ITEM: 6.11	REPORT SUMMARY MINOR VARIANCE APPLICATION FILE NUMBER A085/24
-------------------	--

MINOR VARIANCE APPLICATION FILE NUMBER A085/24

CITY WARD #:	2
APPLICANT:	Silva Petrasso, Tony Petrasso and Vince Anthony Petrasso
AGENT:	None
PROPERTY:	2 Woodland Trail Court, Woodbridge
ZONING DESIGNATION:	See below.
VAUGHAN OFFICIAL PLAN (2010) DESIGNATION:	Vaughan Official Plan 2010 ('VOP 2010'): "Low-Rise Residential"
RELATED DEVELOPMENT APPLICATIONS:	None
PROPOSAL:	Relief from the Zoning By-law is being requested to permit a proposed cabana.

#	Zoning By-law 001-2021	Variance requested
1	A residential accessory structure with a height greater than 2.8 m shall not be located closer than 2.4 m to any lot line. [Section 4.1.2 b].	To permit a residential accessory structure with a height greater than 2.8 m to be located 1.22 m from the interior side lot line.

SITE PLAN, FLOOR PLANS
AND ELEVATIONS

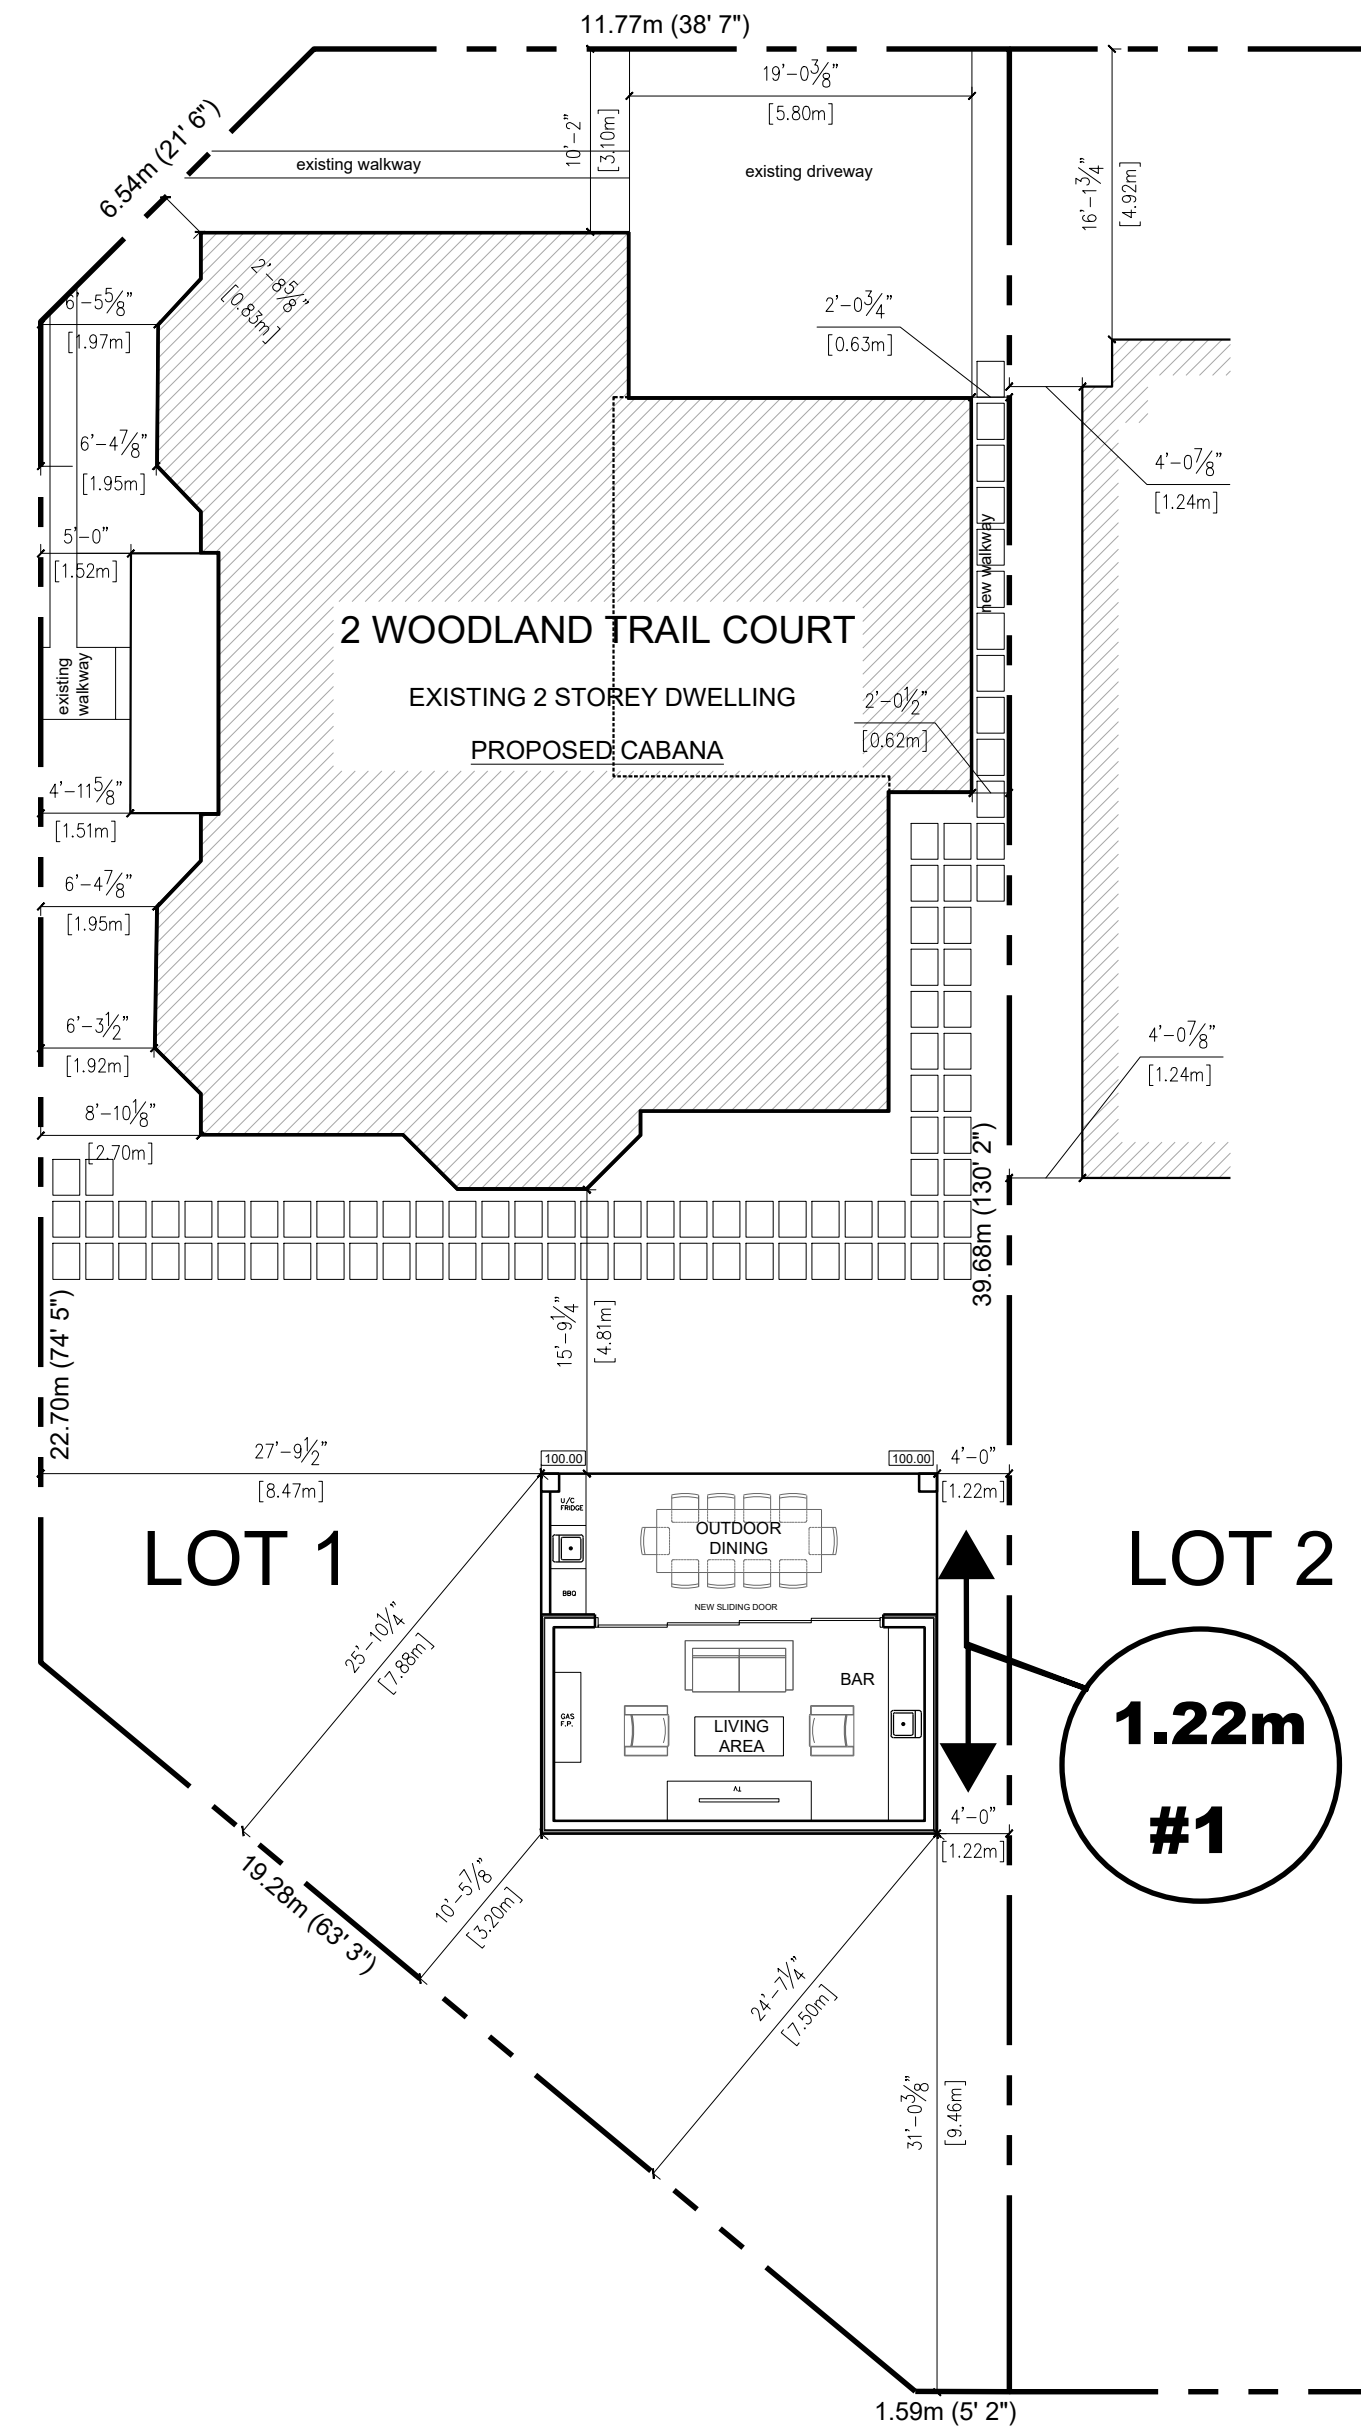
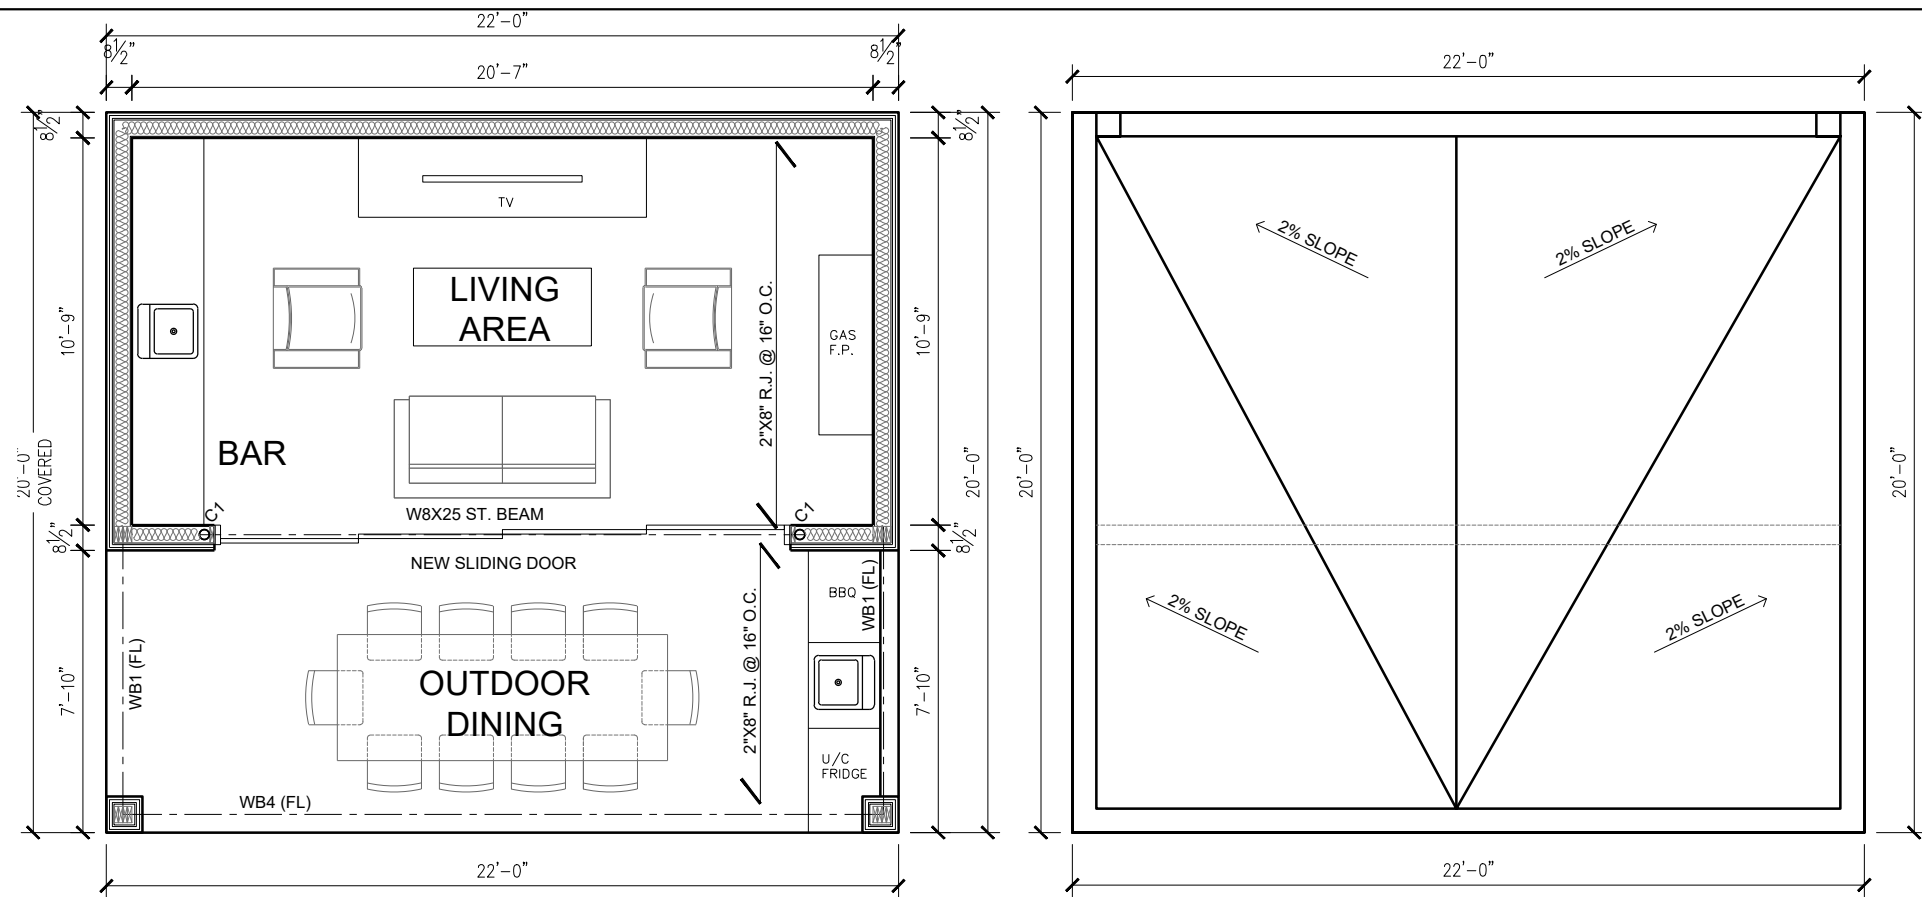
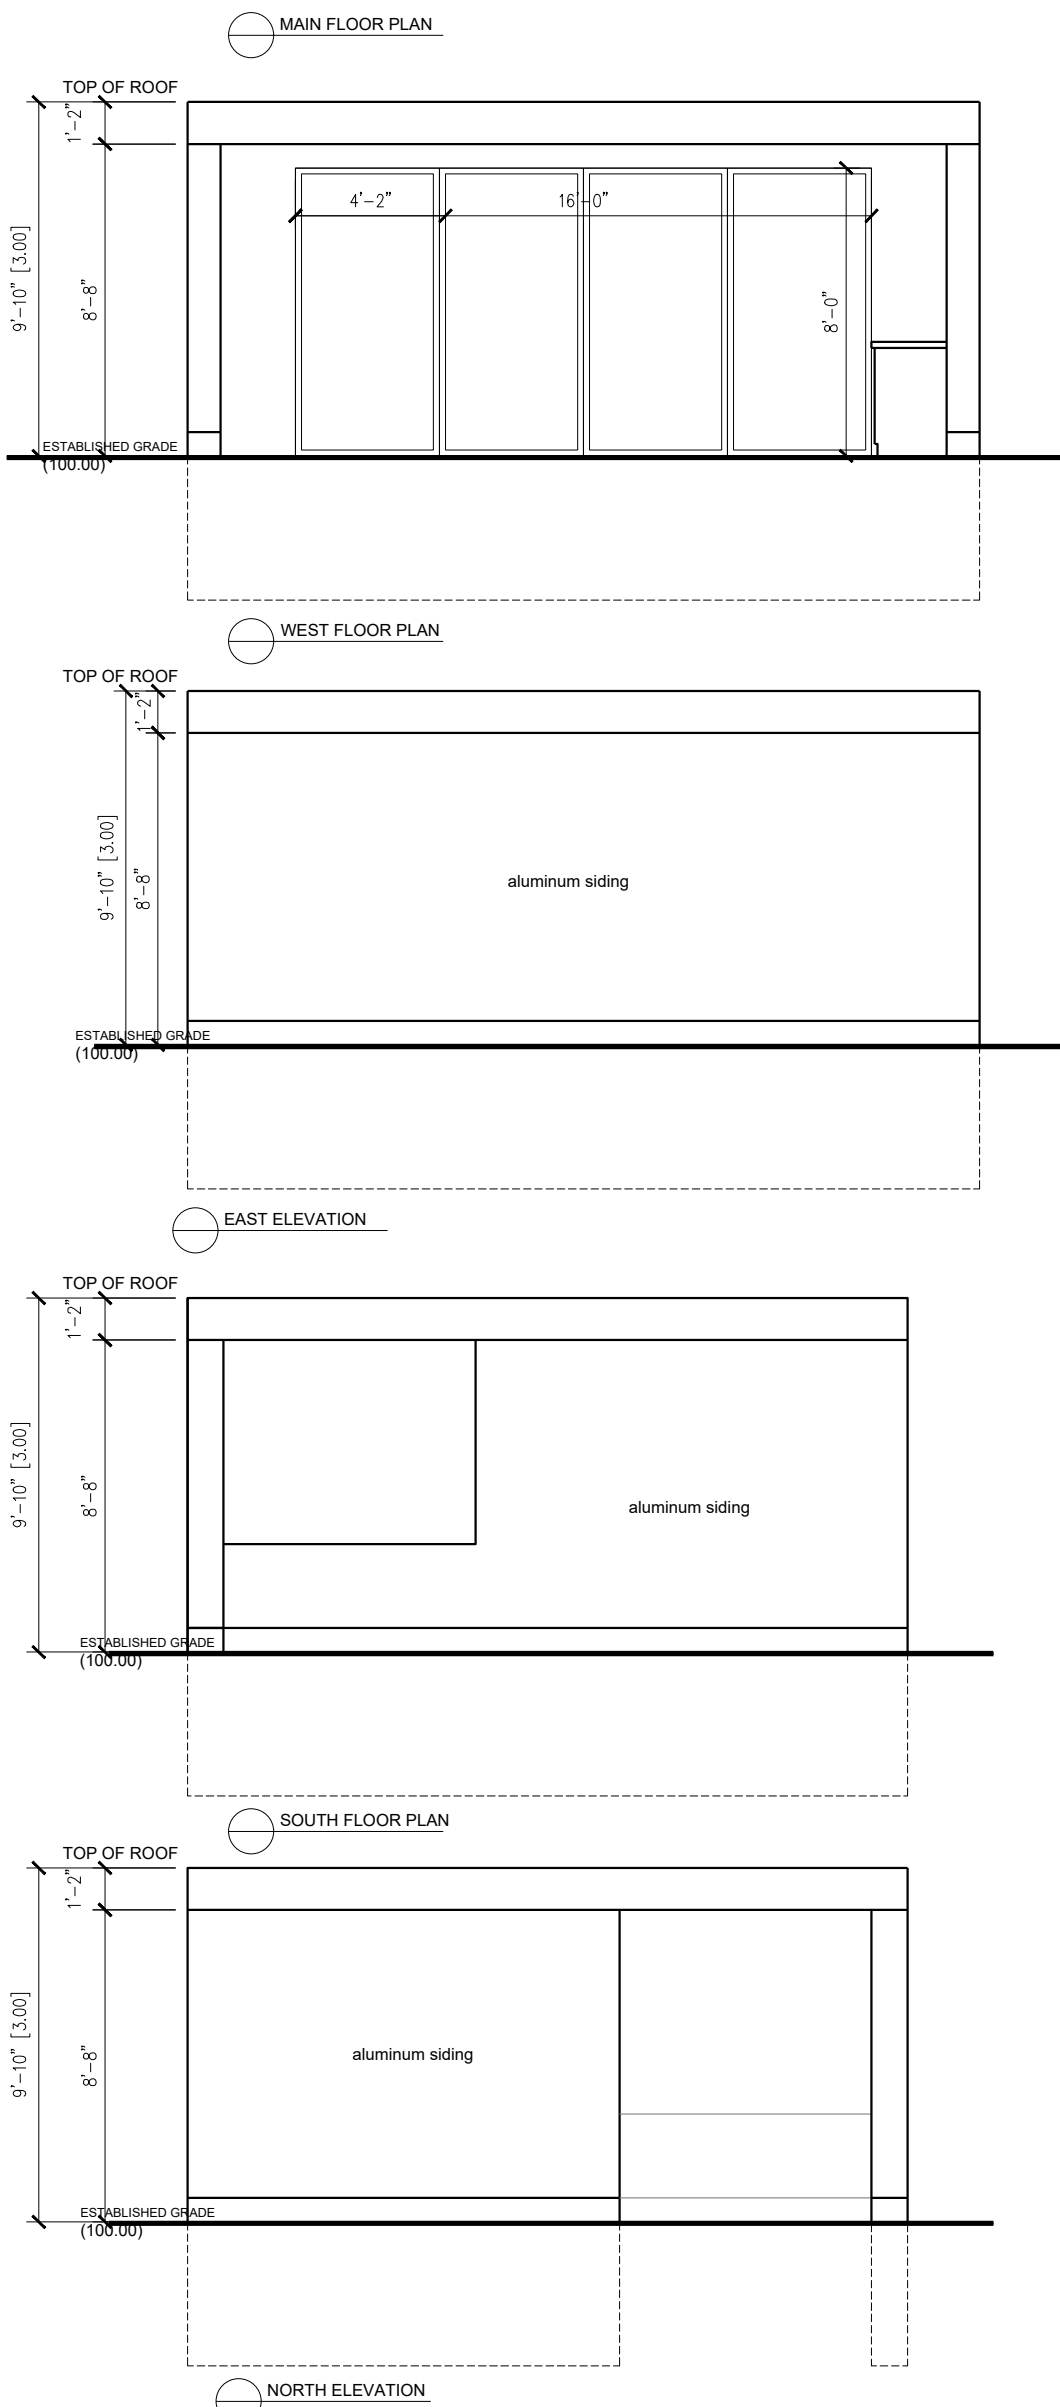
Due to the size of the proposed cabana on the subject property, which measures a total of 40.88 m², the Owner/Applicant must acquire a Lot Grading Permit from the Development Inspection and Lot Grading Division of the City's Development Engineering Department. It's important note that any in-ground structure exceeding 10 m² necessitates a Grading Permit. Once the Grading Permit is obtained, please reach out to the Development Engineering Reviewer to clear the Condition imposed on this application. The Development Engineering Department does not object to the Minor Variance application A085/24, subject to the following condition(s):

Development Engineering Recommended Conditions of Approval:	The Owner/Applicant shall submit an application and obtain an approved Grading Permit before initiating any work on the property. The Final Lot Grading and/or Servicing Plan will be required for the Grading Permit Application. Please visit the Permits page of the City of Vaughan's website: Permits City of Vaughan to apply for a Grading Permit. For any inquiries regarding the Grading Permit, please email DEPermits@vaughan.ca
--	---
